A Jensen Hughes Company

## Regis Aged Care

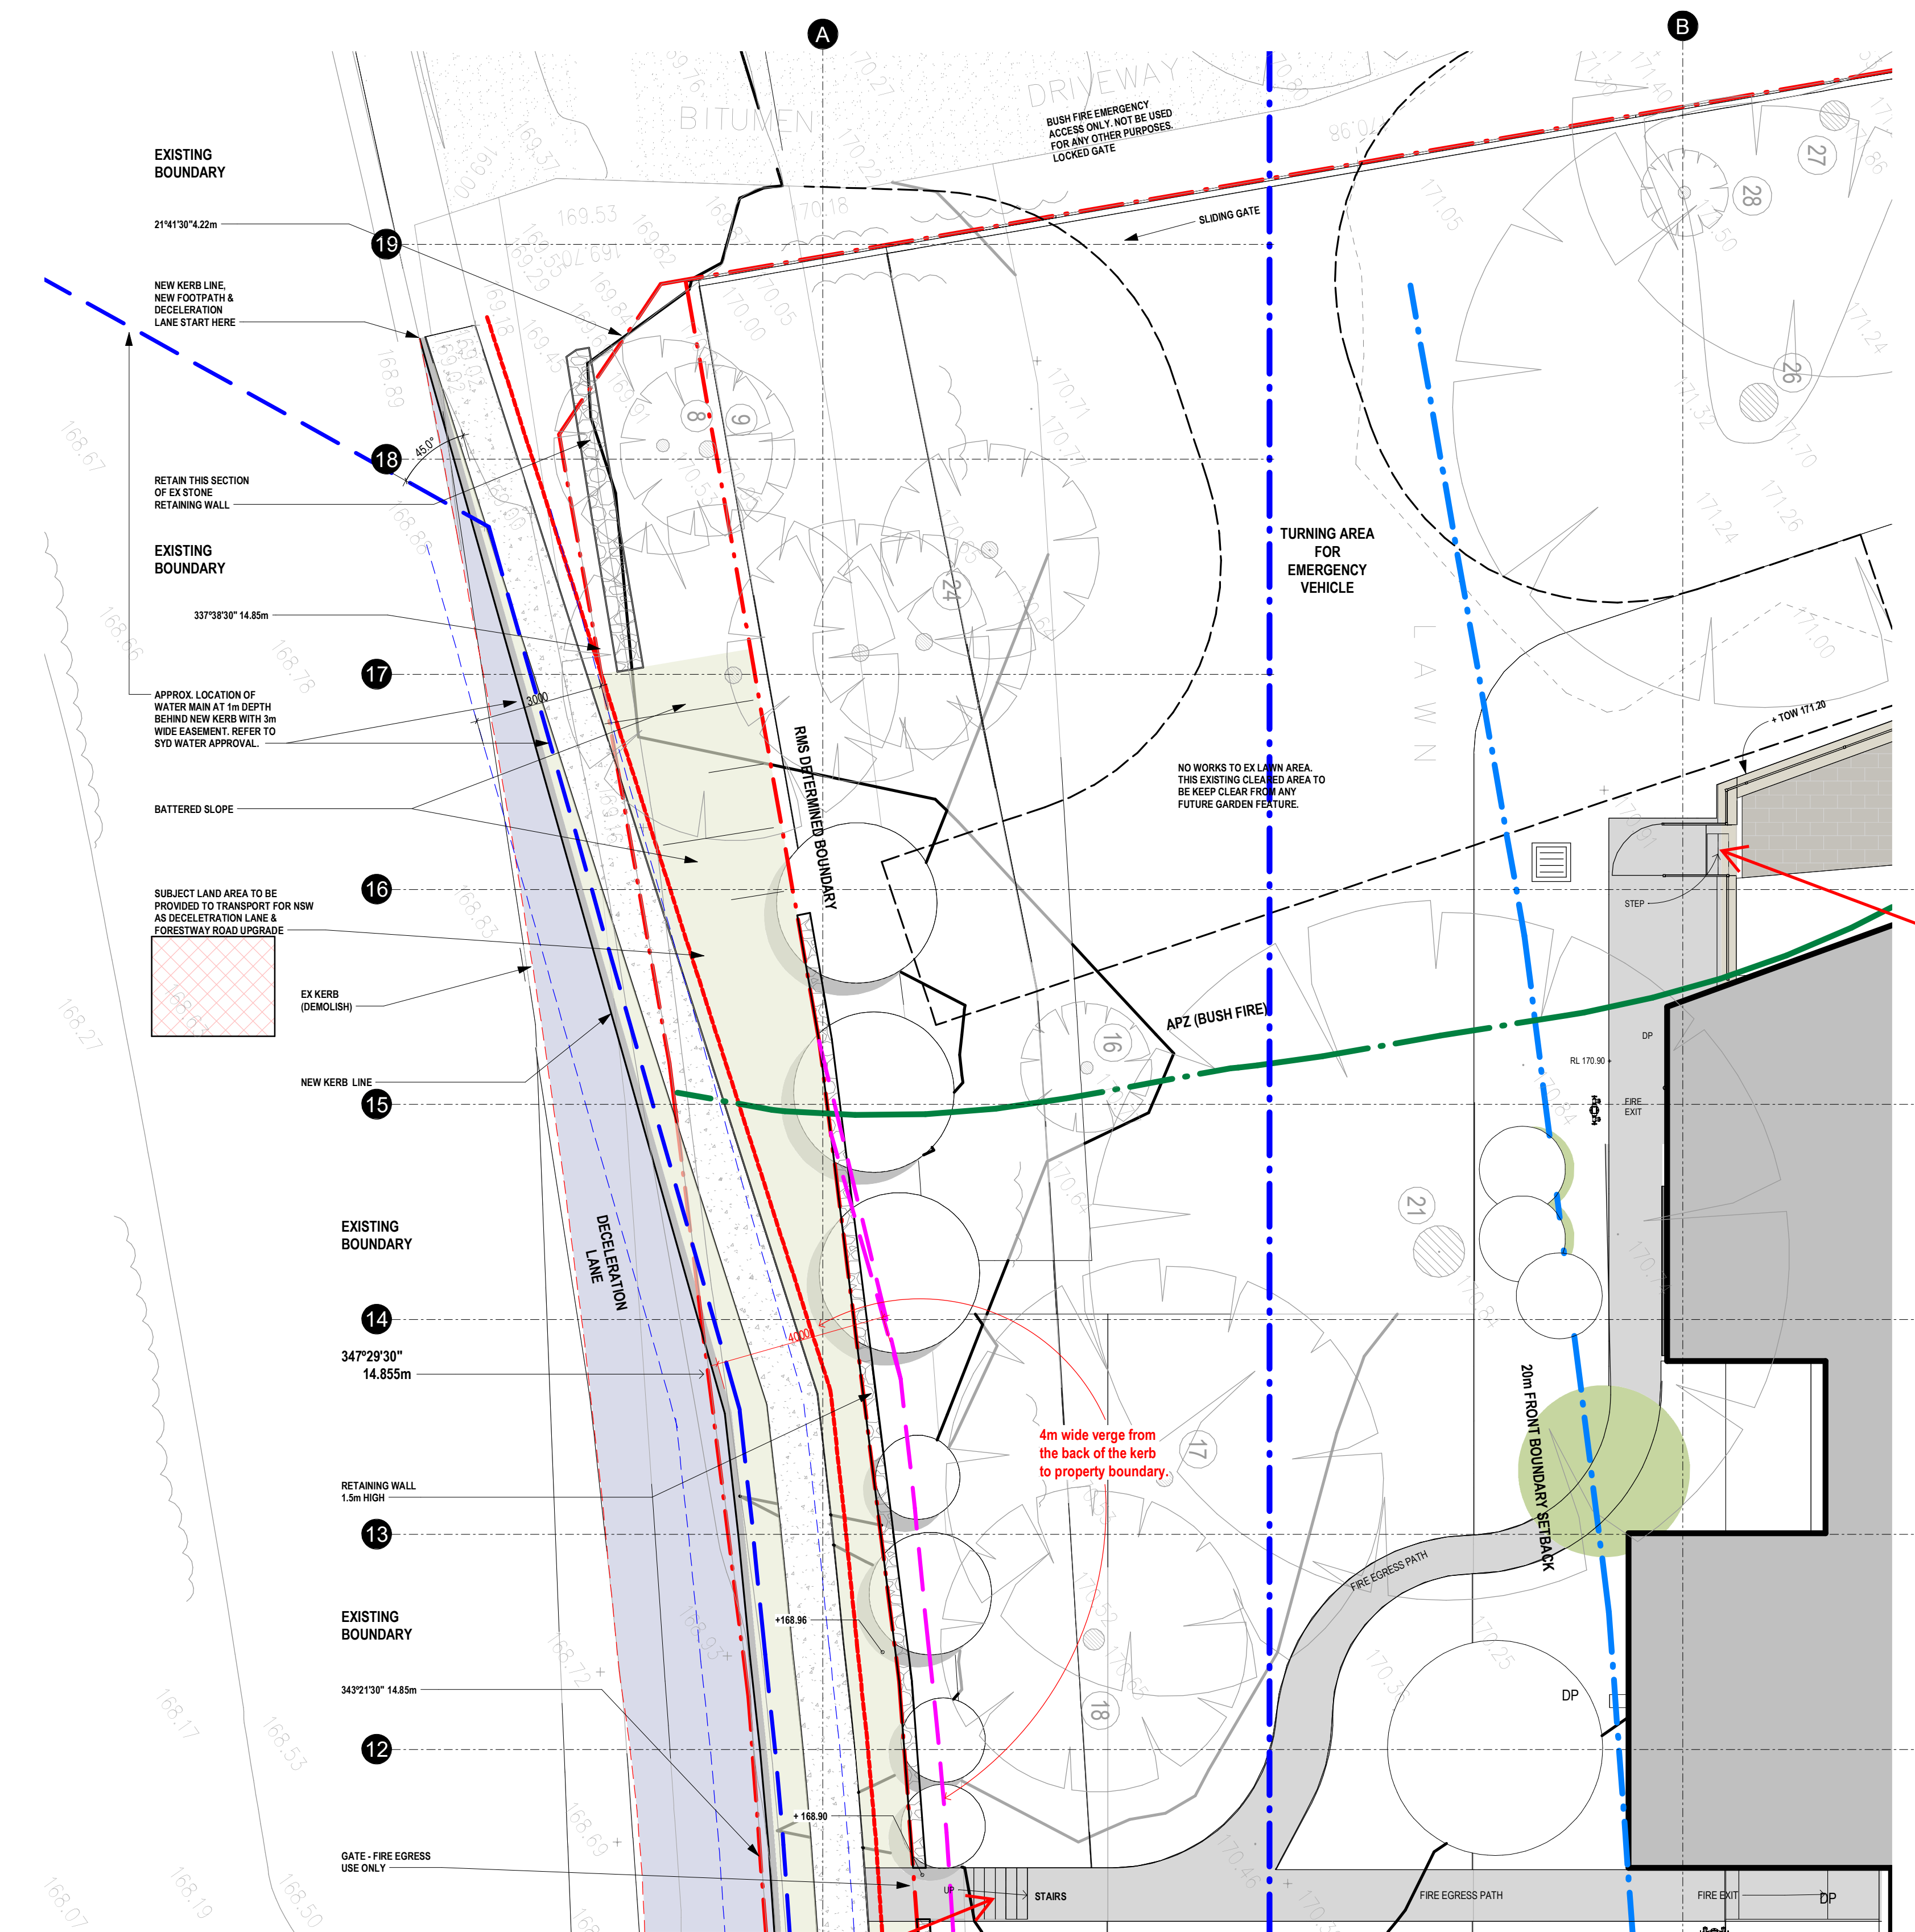
<b>22. Car Parking</b>				
22.1.	Bollards and shared area markings not shown.	Show bollards and markings to shared areas.		<b>OPEN</b>
		Refer to drawing mark-ups. Refer to Design checklist for more information.

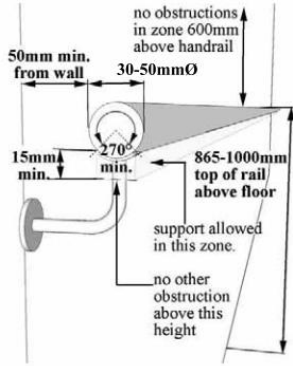
10.1.	<p>Under BCA Part D2.15, an AS1428.1 threshold ramp is generally only permitted at external doorways i.e. connects to a road or open space clarification needs to be sought from PCA on this issue as there may be concessions for some building classifications e.g. 9a, 9c.</p>  <p style="text-align: center;">DIMENSIONS IN MILLIMETRES</p>
